MEMORANDUM

To: Development Review Board
From: Mary O'Neil, AICP, Principal Planner
Date: November 2, 2021
RE: ZP21-614; 77-87 Pearl Street (6 Pine Street)

Request: Demolish carriage barn and return to green space. Structure is listed on the Vermont State Register of Historic Resources.

This photograph was taken for the 2016 review. Similar photographs are within the Van Dyk report.

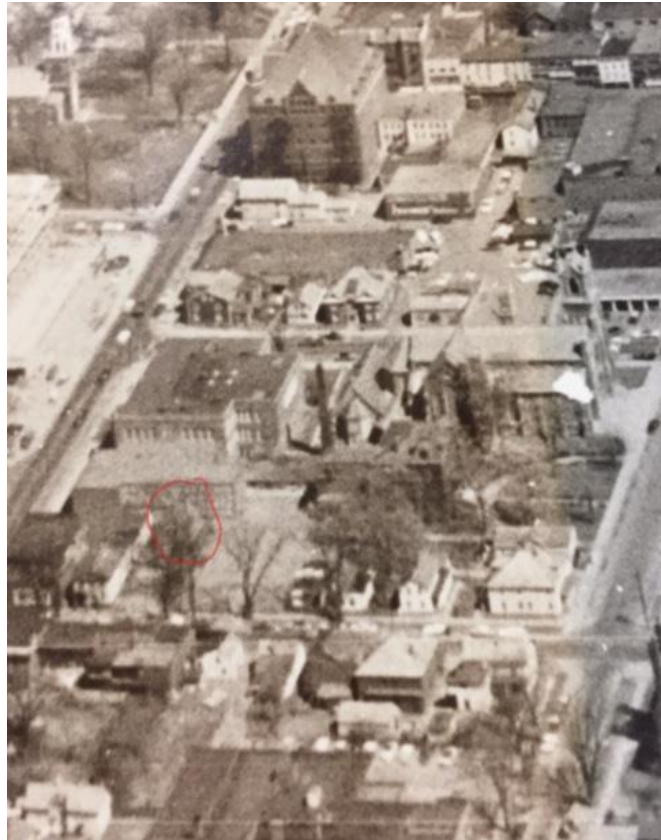
Observation shows evidence of fire damage (south elevation, boarded over), a failing chimney and soffit with holes. There are no building permits on file specifically for repair of the barn.

Please refer to report by Van Dyk for assessment of structural stability and building condition, which he determines to be in “progressive failure.”

PHOTO 1: South-West Corner - Note ridge sag, swale in roof plane and hole in roof near chimney

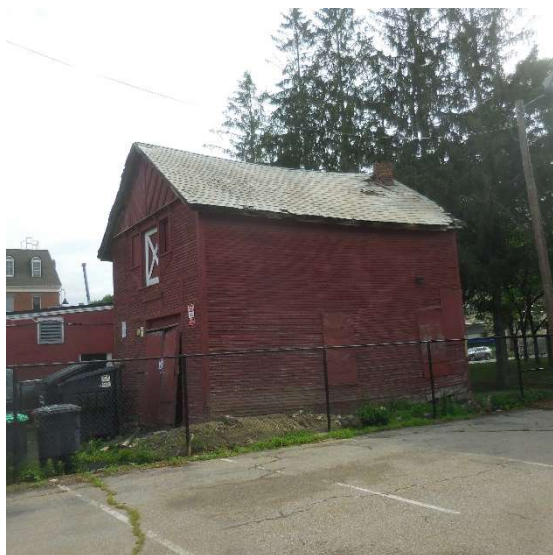
1. Wood framed walls bear on a foundation that appears to be 6” or more below grade. Wood components (mudsill, studs, sheathing, etc.) that are at or below grade show signs of decay and deterioration (PHOTOS 3 & 4).

2. There is a significant sag in the roof ridge and visible “swales” in the roof plane on either side of the ridge (PHOTO 1); both sag and swales seem to indicate excessive deformation of roof framing elements.

77-87 Pearl St. / 6 Pine St. – Site Plan

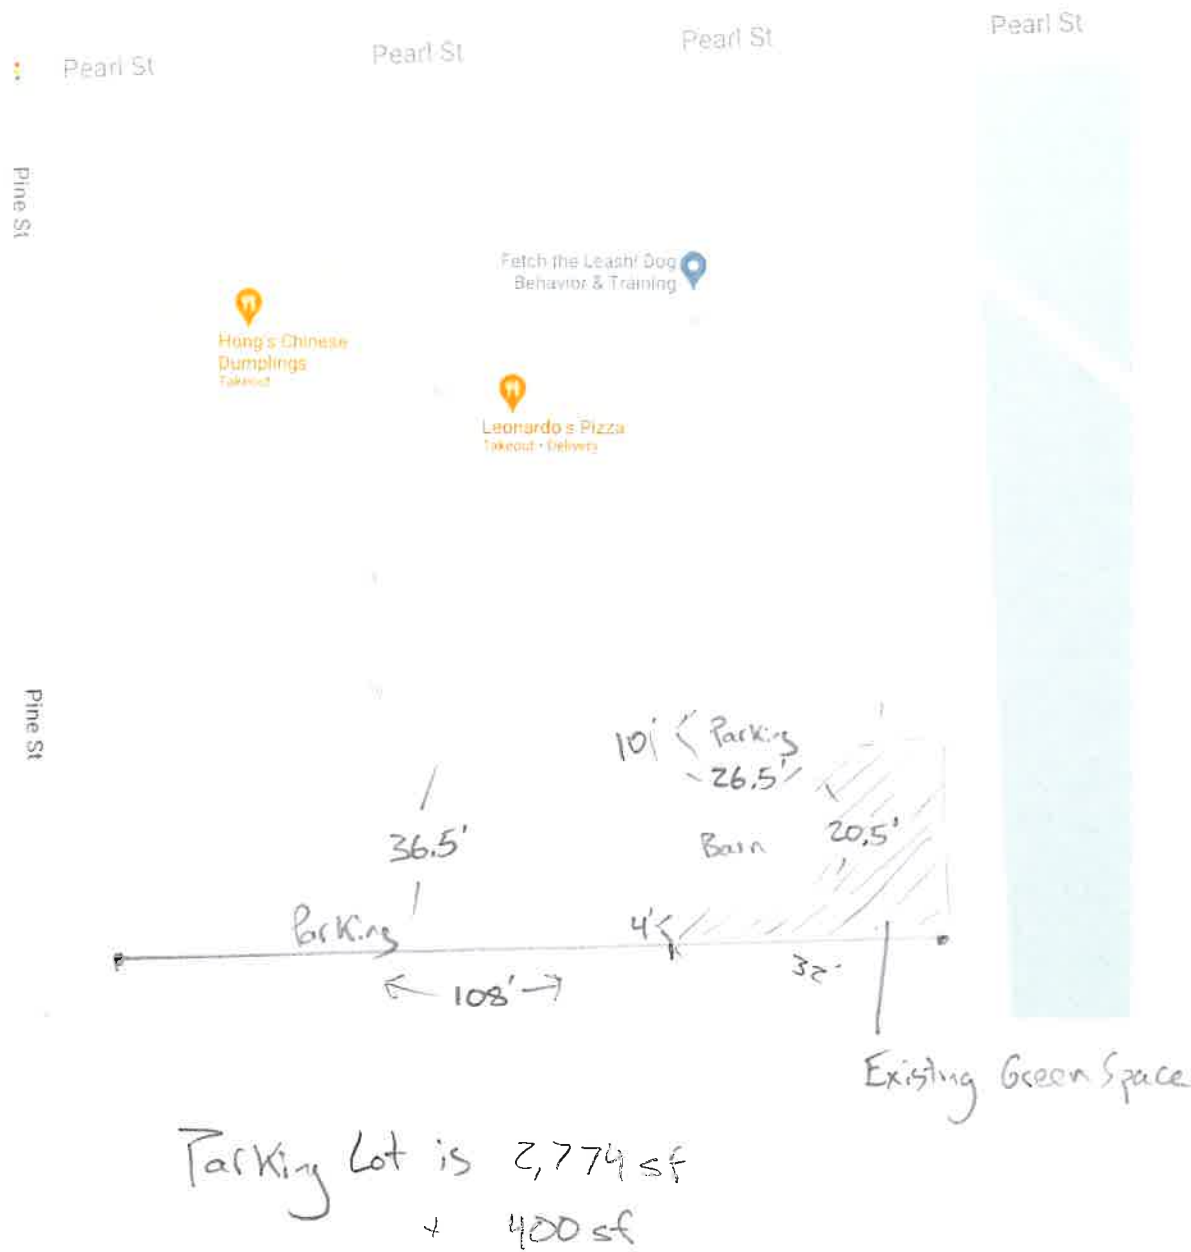
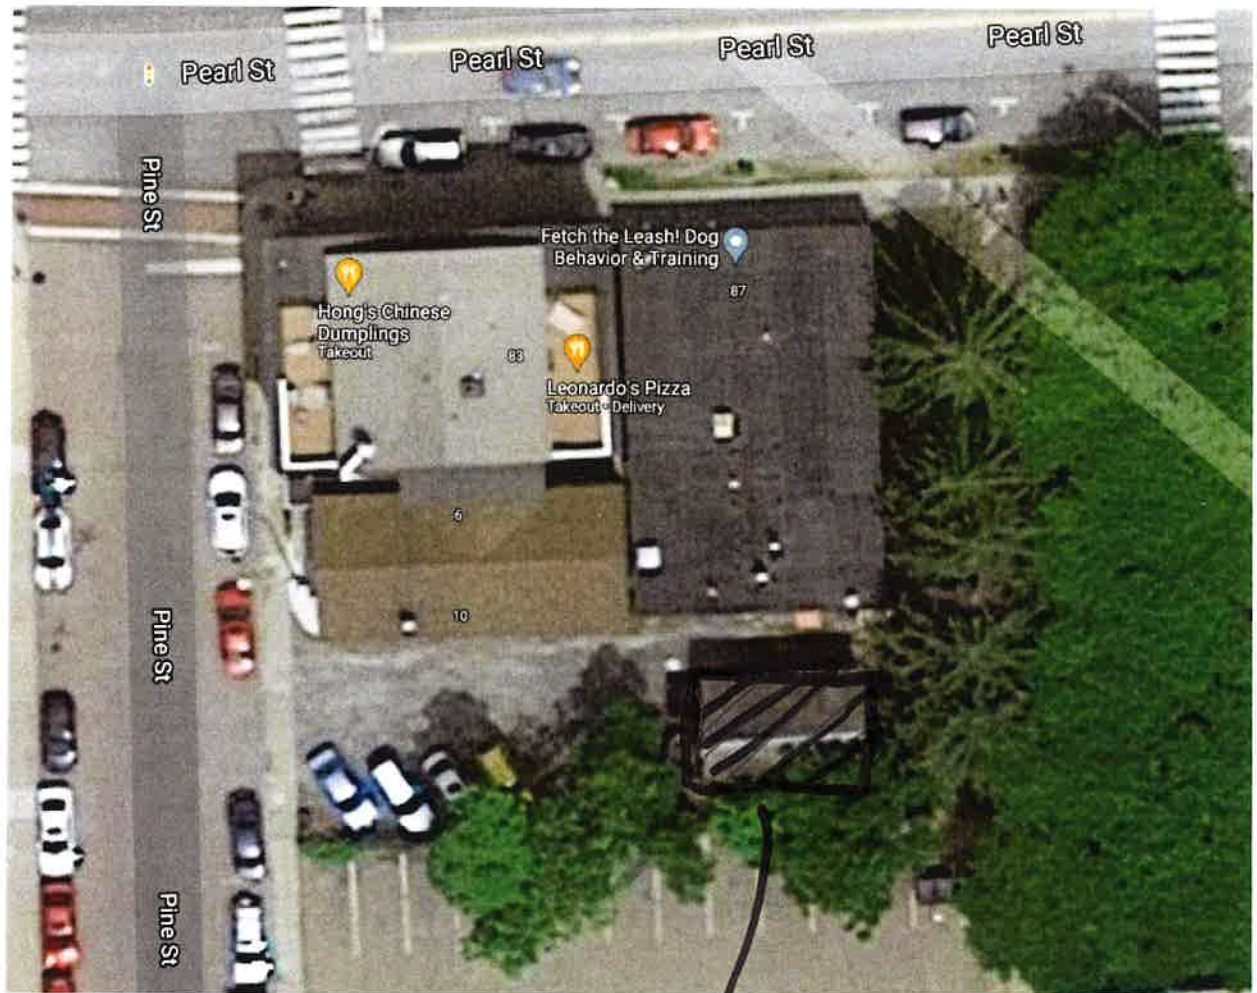
The submitted plan is an annotated Google image with the location of the barn identified as green space. An overall coverage calculation has not been submitted.

The applicant proposes an immediate demolition and installation of 543 sf of green space. There is no identification of the location for relocated dumpsters on the submitted site plan. No replacement structure is proposed. A small green space will not measureably enhance the architectural character of the immediate area, neighborhood or district.

A site visit February 2, 2016 illustrated parking for 7 car; six in angled spaces in front of the barn, and one next to it. The submitted site plan does not account for relocation of two dumpsters which currently sit west of it.

No change to access is proposed. If approved, a scaled site plan with parking (and green space annotated) shall be provided. **Affirmative finding if conditioned.**

4. A minimum 10% pervious area shall be provided onsite. The applicant shall submit a detailed site plan that defines that minimum.
5. A scaled plan shall be provided to staff that includes the following:

- a) Curb cut not to exceed 15' as approved in the 1980 plan;
 - b) All parking spaces identified, with measurements;
 - c) Green space clearly annotated;
